Re: Request for Additional Information
Docket No. 030-36971
License No. 09-23920-01E

A. Information required for review of Sealed Source and Device amendment application.

B. Information required for review of exempt-distribution license amendment application

NM1092C

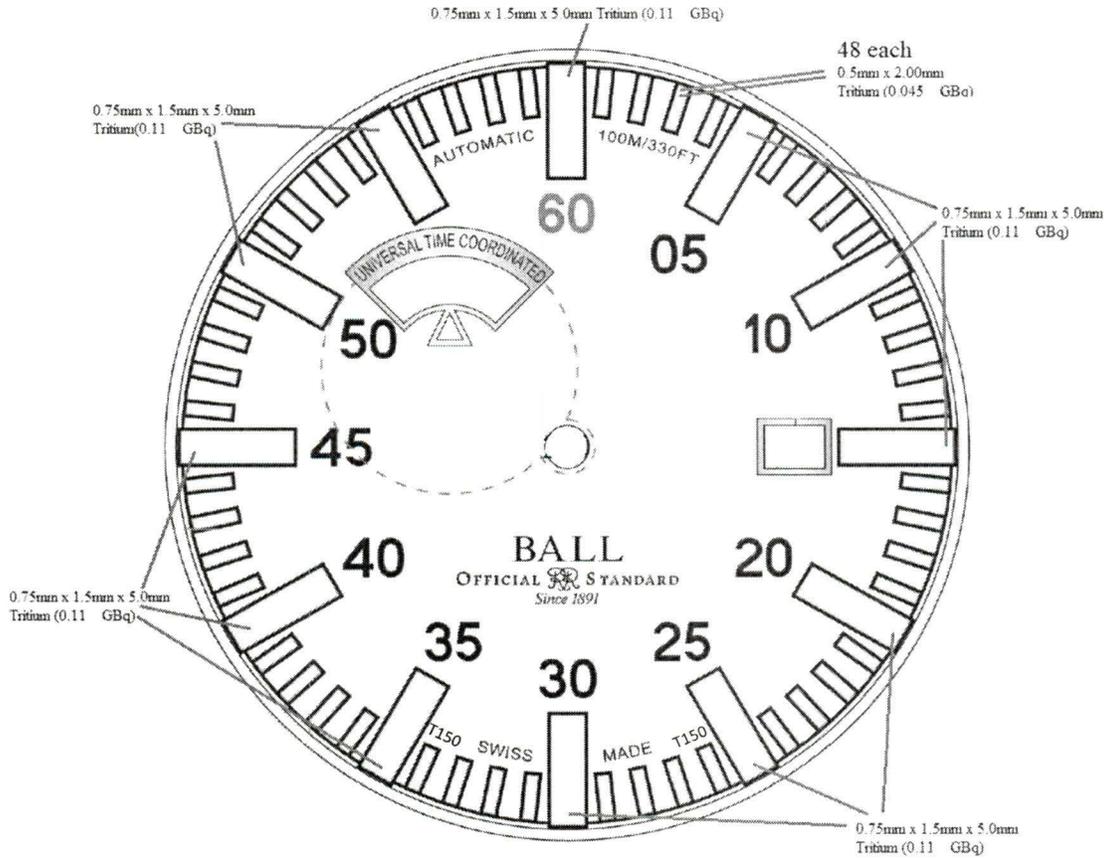
1. Model NM1092C is the proper and complete designation for the model timepiece.
2. Model NM1092C will have a maximum activity of 102.3 mCi (3.79 GBq).
3. See Attachment "A". The location will be on the lower face of the timepiece.

48 each 0.5mm x 2.00mm (0.045 GBq) total = 2.16 GBq Dial 1-12h
 11 each 0.75mm x 1.5mm x 5.0mm (0.11 GBq) total = 1.21 GBq Dial 1-11h
 1 each 0.75mm x 1.5mm x 5.0mm (0.11 GBq) total = 0.11 GBq Dial 12h

1 each 0.65mm x 4.10mm (0.134 GBq) total = 0.134 GBq Hour hand
 1 each 0.50mm x 6.50mm (0.137 GBq) total = 0.137 GBq Minute hand
 1 each 0.50mm x 1.64mm (0.035 GBq) total = 0.035 GBq Second hand

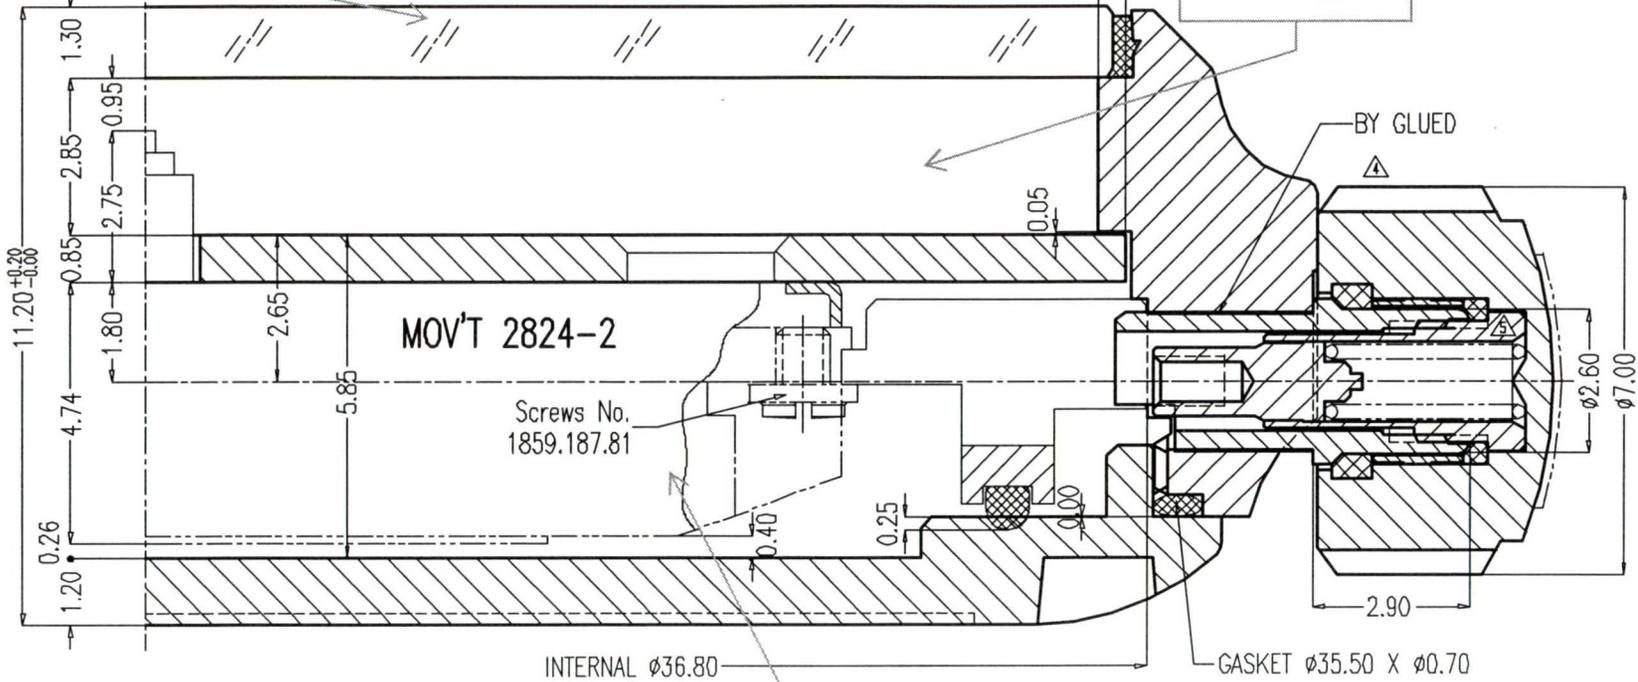
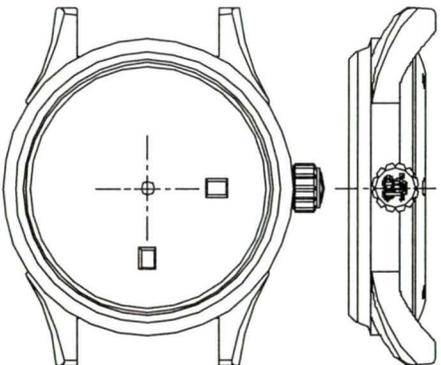
1. Attachment "B" is a cross section of the timepiece. The crystal is constructed of sapphire glass. The sapphire glass is permanently sealed to the bevel encasing the GTLSs. The only accessible part of the timepiece is through the underside which will allow access to the mechanical movements of the timepiece. Access to the underside requires specialized tools and is not a function of normal operation or use of the timepiece.

For all GTLS tubes to simultaneously rupture would require a destruction of the timepiece crystal. The timepiece crystals are sapphire. Sapphires (also known as Corundum) have a hardness of 9 on the Mohs scale. Sapphires are mechanically second only to a diamond which has the maximum hardness of 10 on the Mohs scale. Sapphire glass is one of the hardest and most scratch resistant materials available. The high modulus of elasticity and high tensile strength make it extremely wear, abrasion and impact resistant.

Even in the event all GTLS tubes becoming damaged, the H-3 would still be sealed between the sapphire crystal and hardened steel which has a hardness of 7-8 on the Mohs scale.
